ALASKAN WAY VIADUCT

EVALUATION OF GRAY'S RETROFIT PROPOSAL

Prepared for the
Washington State Department of Transportation

By
T.Y. Lin International

Figure D.9a Column curvature ductility demand, retrofitted structure, design earthquake, longitudinal direction

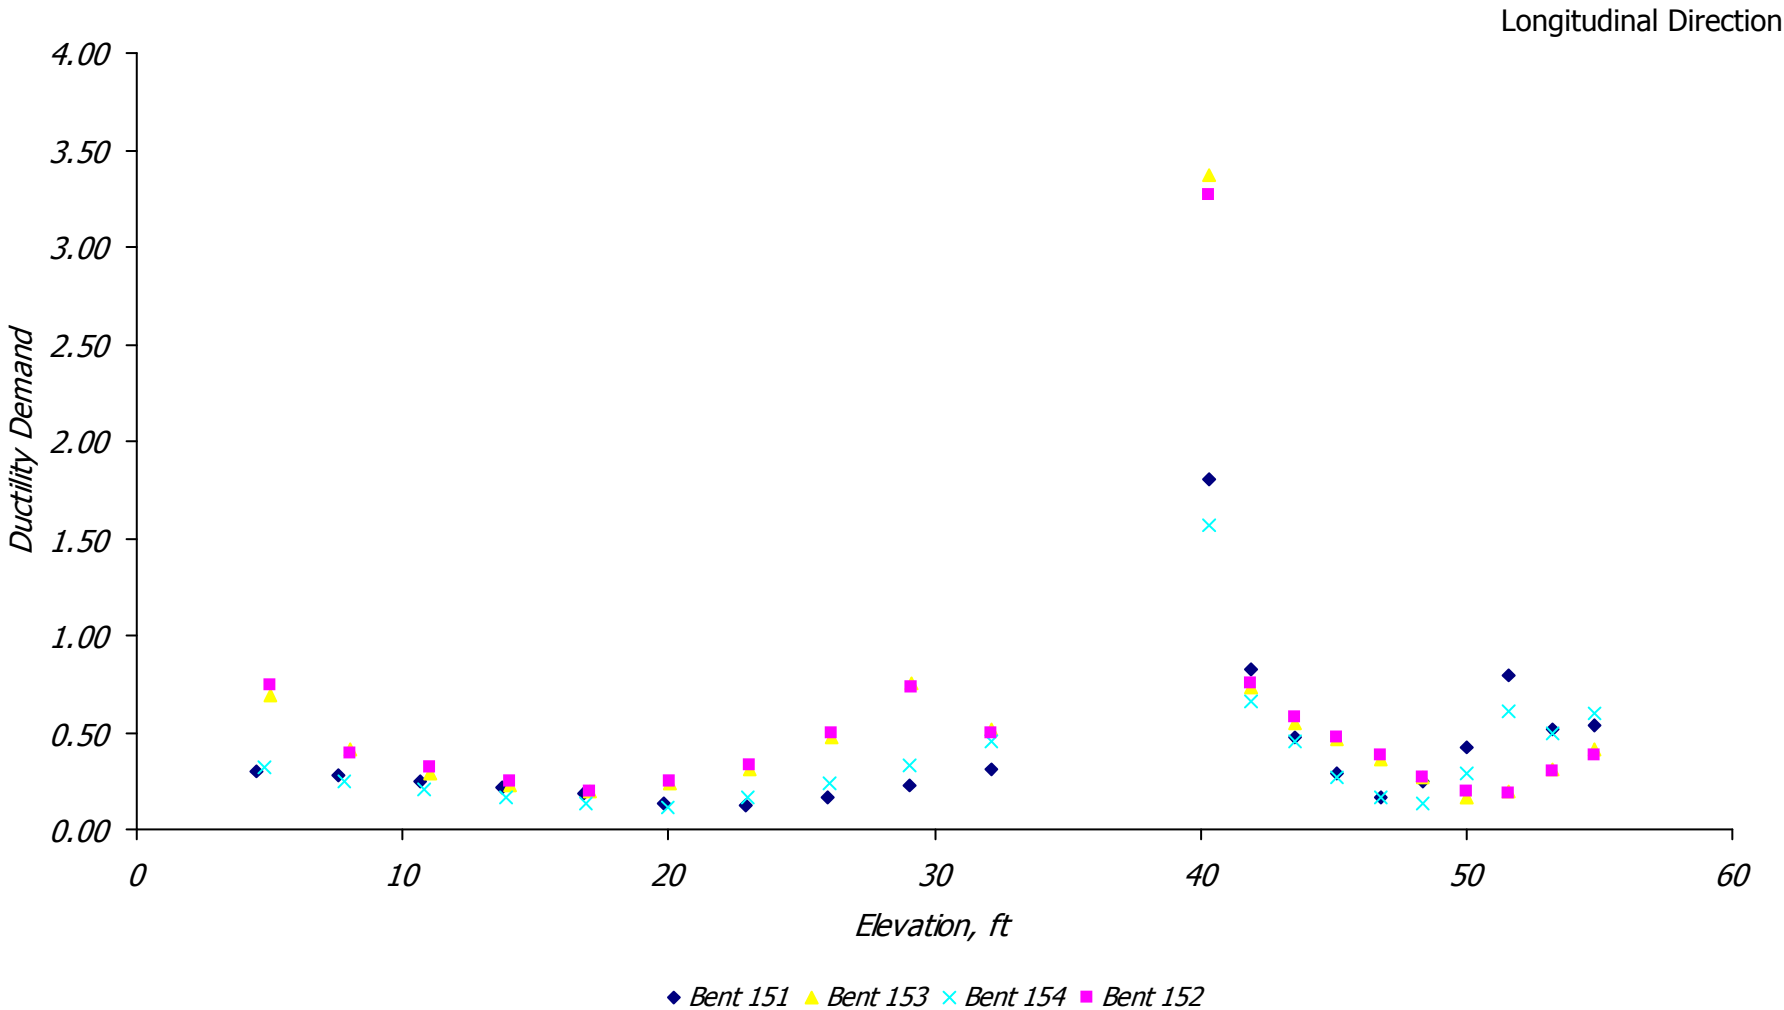
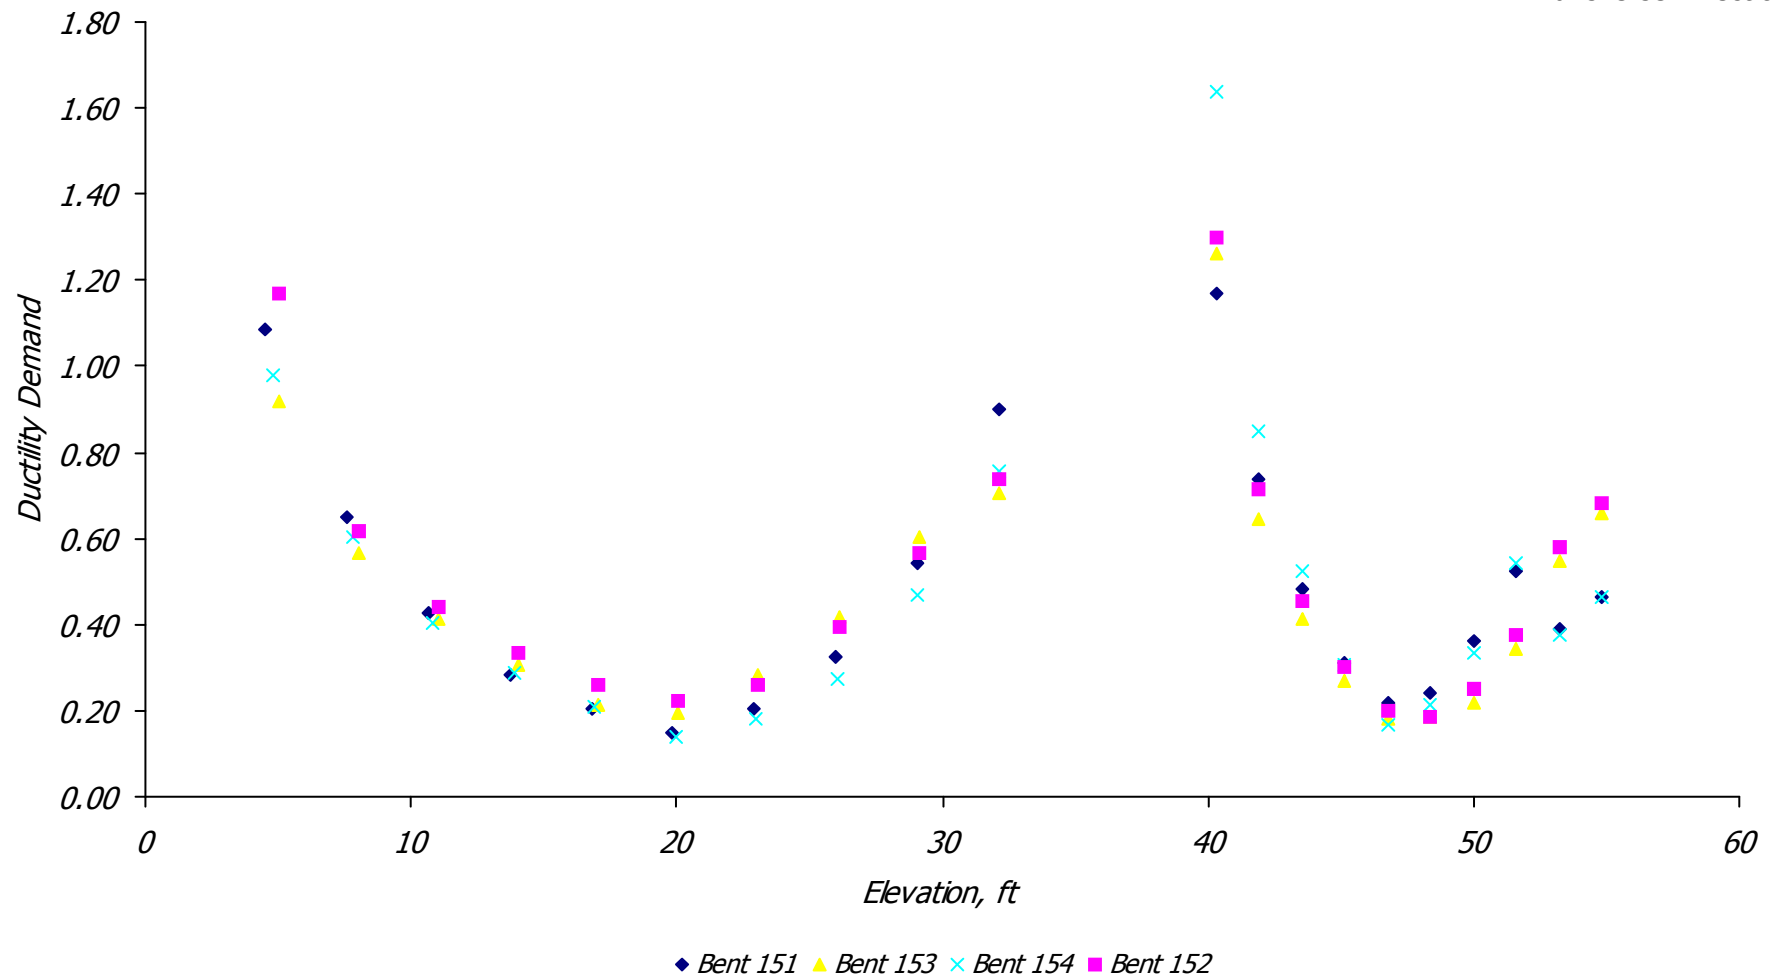
For the design earthquake, the curvature ductility demands on the columns are summarized in Figure D.9. These demands are consistent with repairable damage. Some degradation of the reinforcing bar splices in the upper columns may be expected unless the columns are retrofitted, say with fiber wrap.

Figure D.11a Floorbeam curvature versus axial force, retrofitted structure, rare earthquake, upper level

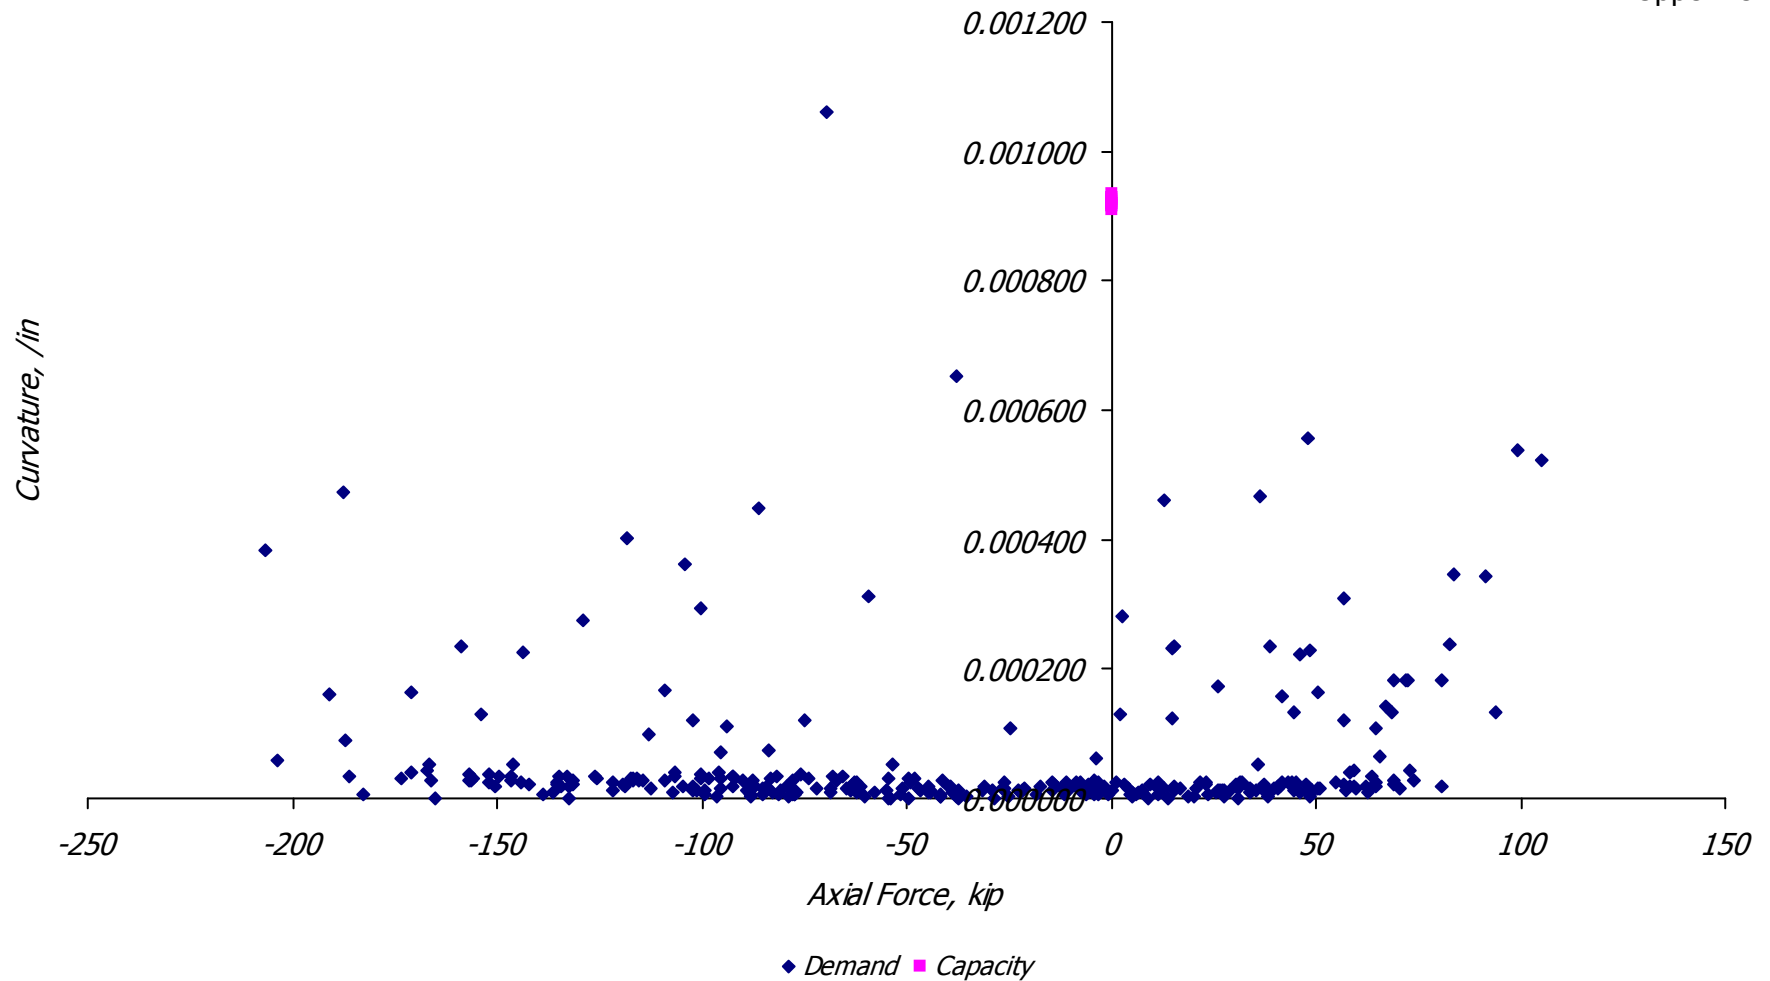
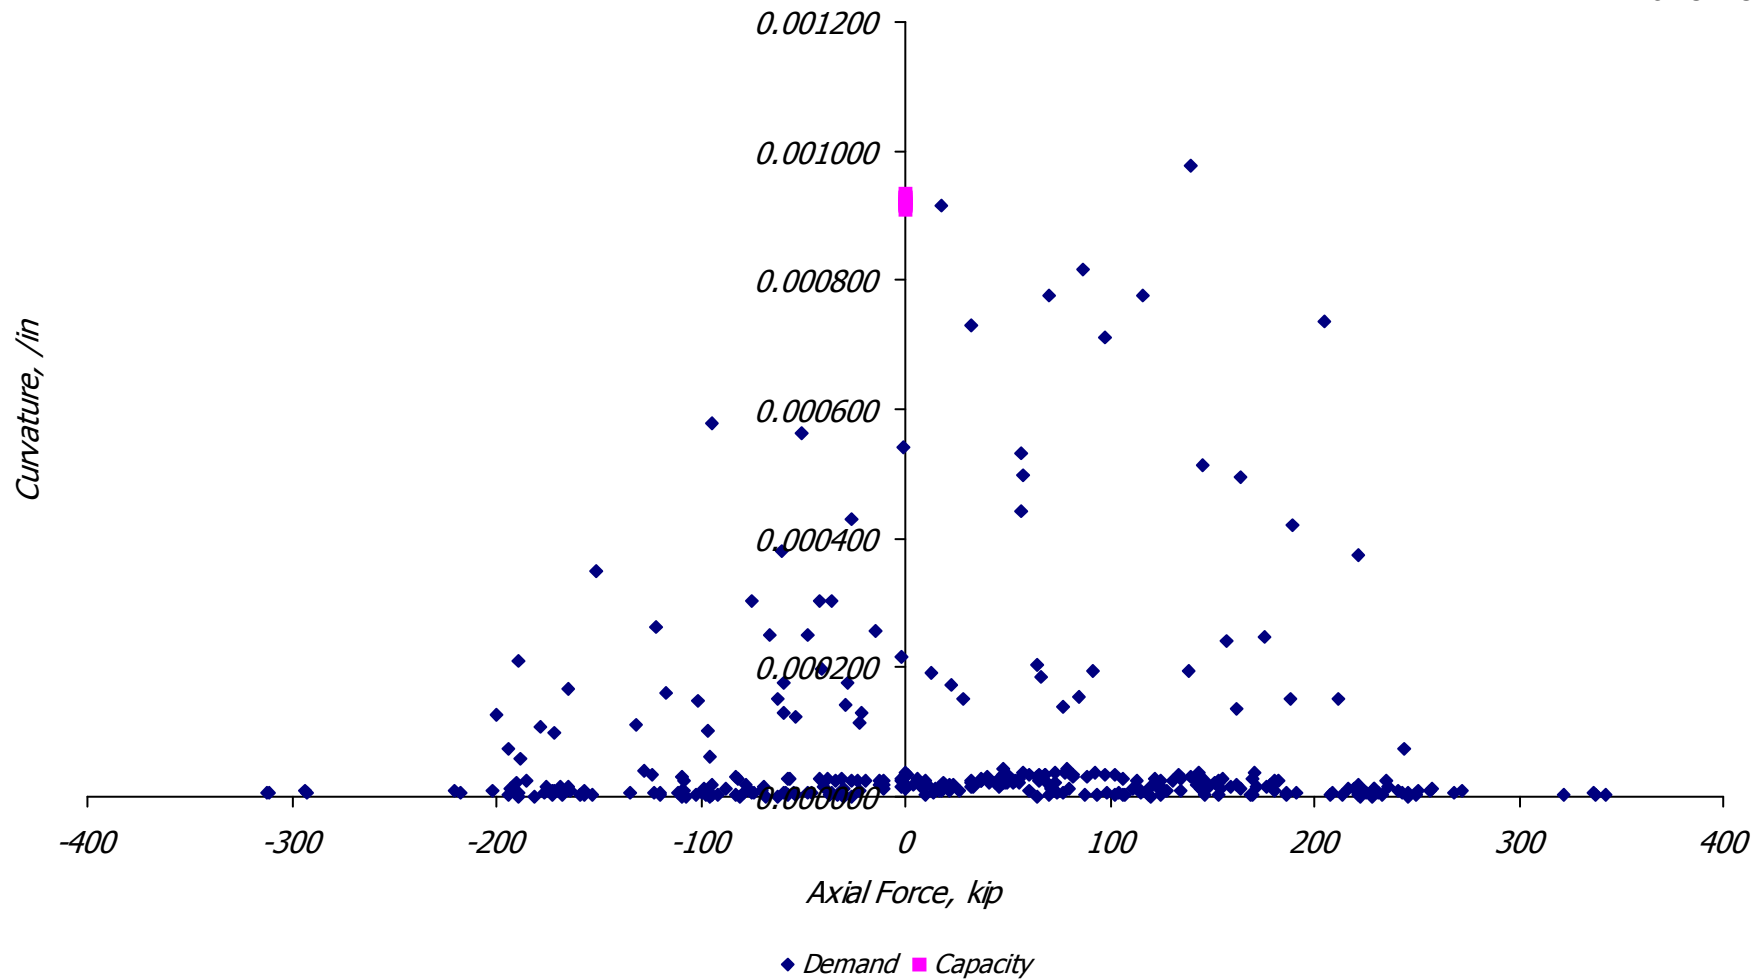
Plots of simultaneous curvature and axial force demands on the floorbeams are shown in Figure D.11; there are separate plots for the upper and lower level floorbeams. The capacity curves are represented by clusters of points along the curvature axes (for axial forces of zero). This is because the capacities of the various floorbeams sections are nearly the same, and because the capacity was only calculated for an axial force of zero (because the axial forces in the floorbeams are modest).

Figure D.11 indicates that the floorbeams will fail in flexure—in negative bending near one of the columns. This same failure was predicted by the pushover analysis described previously. A demand/capacity ratio of 1.08 was obtained for the middle bents from that analysis. A similar ratio may be inferred from Figure D.11b.

Figure D.12a Floorbeam curvature ductility demand, retrofitted structure, design earthquake, upper level

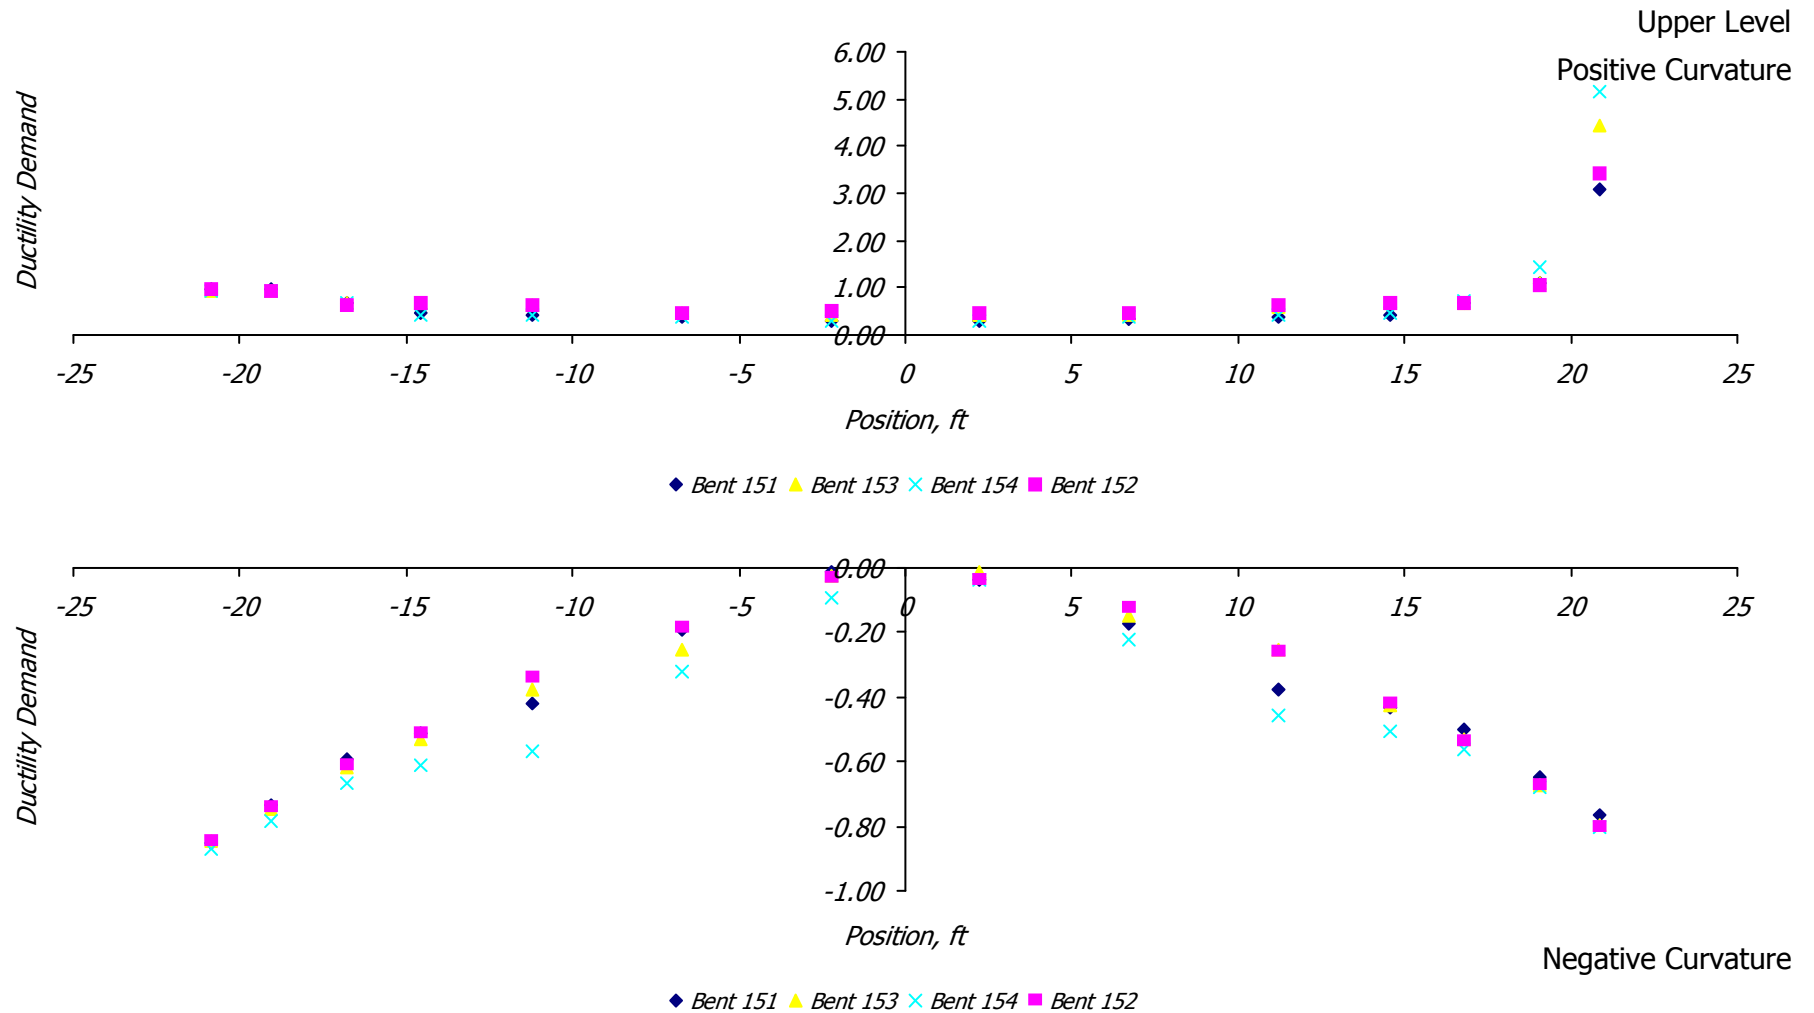
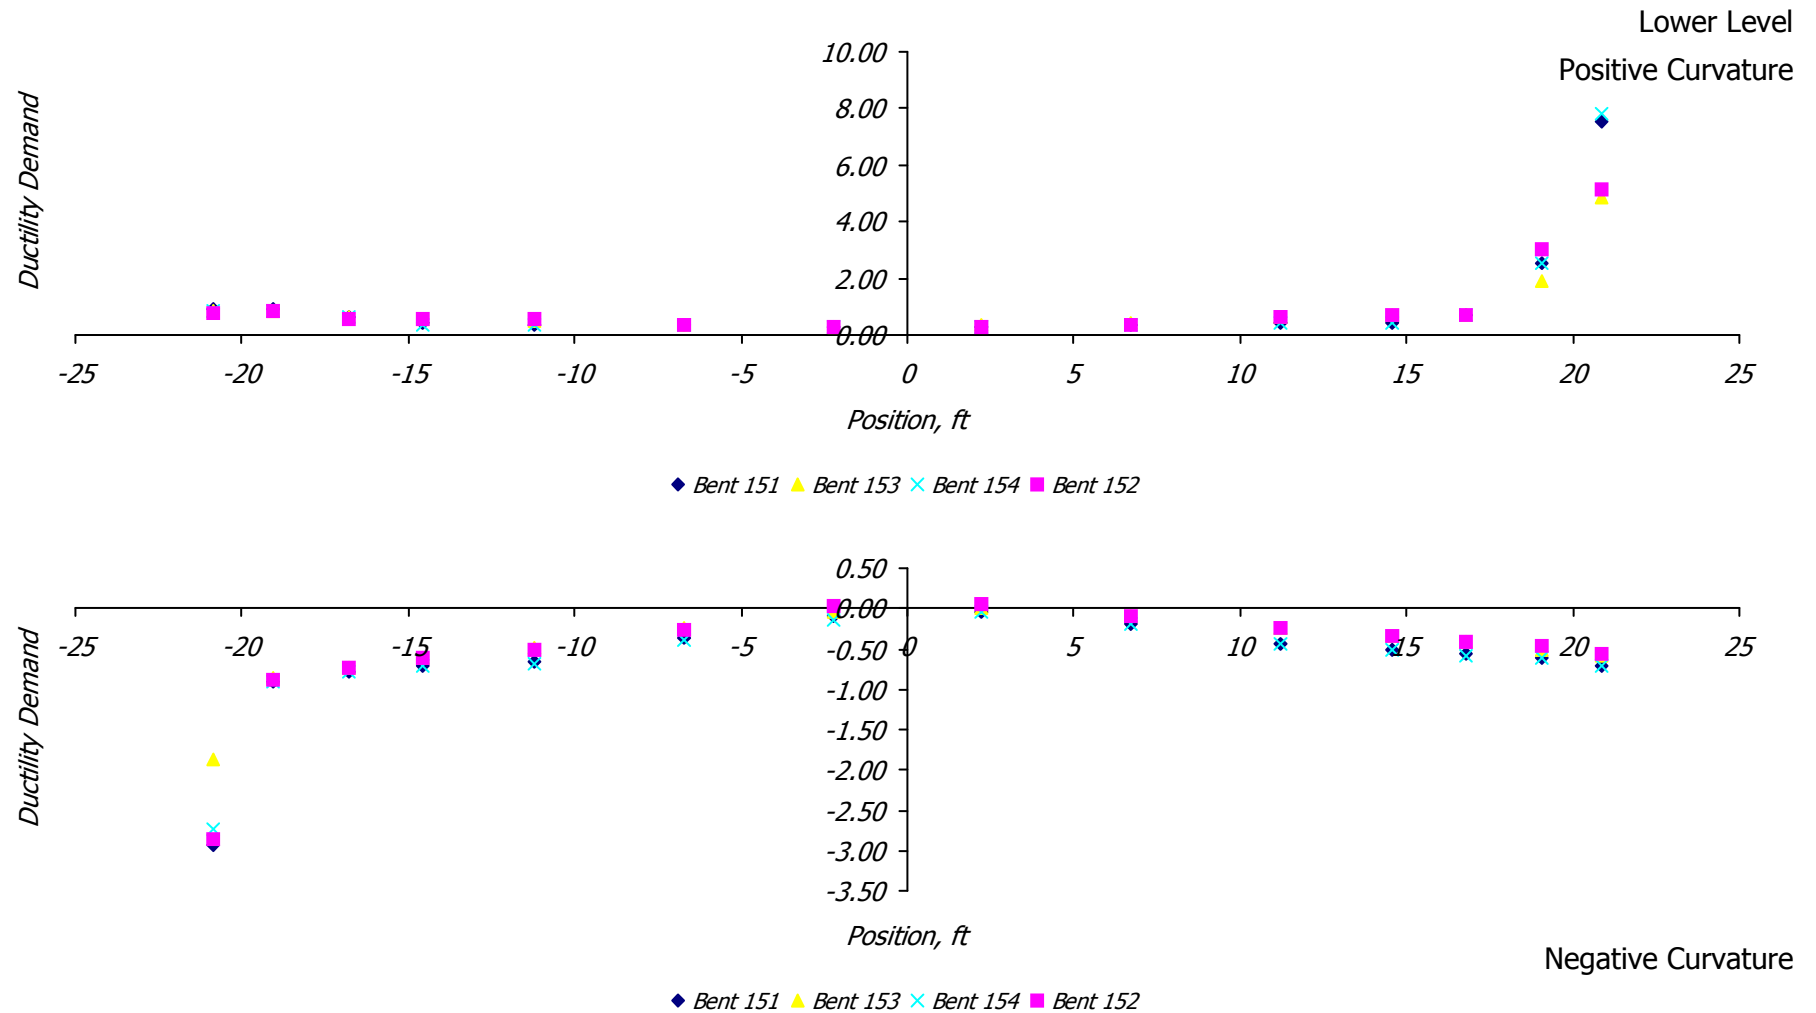
For the design earthquake, the curvature ductility demands on the floorbeams are summarized in Figure D.12. The largest demands are large enough to cause significant cracking and yielding of reinforcement, but within the limits for repairable damage provided that there is not major degradation in development of reinforcing details.
